## Visual and technical change to deflection pulley 532 0410 20

<b>Vehicle manufacturer:</b>	Mercedes, Setra
<b>Models:</b>	
<b>Mercedes</b>	Citaro Conecto Travego
<b>Setra</b>	ComfortClass
<b>Engine:</b>	12.0 litres / 185 - 310 kW
<b>Mercedes</b>	OM 457.942 OM 457.934 OM 457.940 OM 457.936 OM 457.938
<b>Setra</b>	OM 457.941 OM 457.944
<b>OE-No.:</b>	Mercedes A 000 550 13 33
<b>Part no.:</b>	532 0410 20

**INA 0033**

Image 2: 532 0410 20 - new design

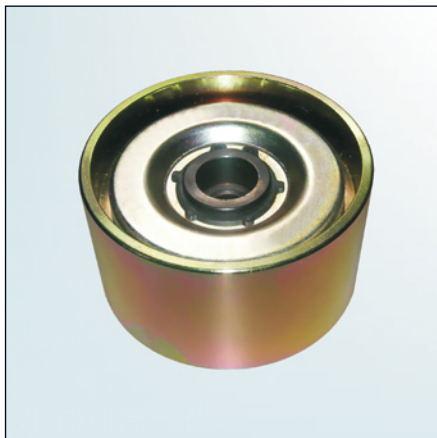
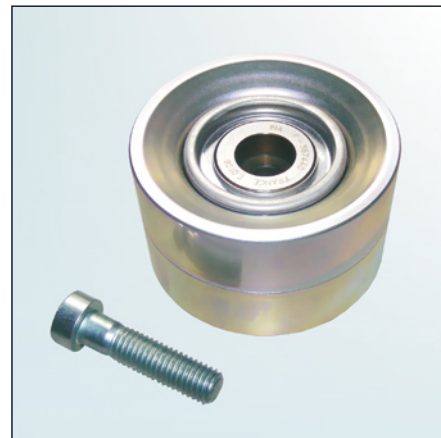
As part of our continuous efforts to improve our products, changes have been made to the deflection pulley, item no. 532 0410 20. This Service Information sheet shows the visual features of the previous design and the new design.

Aside from the different production method and the 4mm wider pulley, the new pulley is lighter (657 g compared to 966 g for the old pulley).

The new version is also supplied with an M10x40 bolt (see Image 2). This replaces the M10x35 fixing bolt with which the previous pulley (see Image 1) was attached
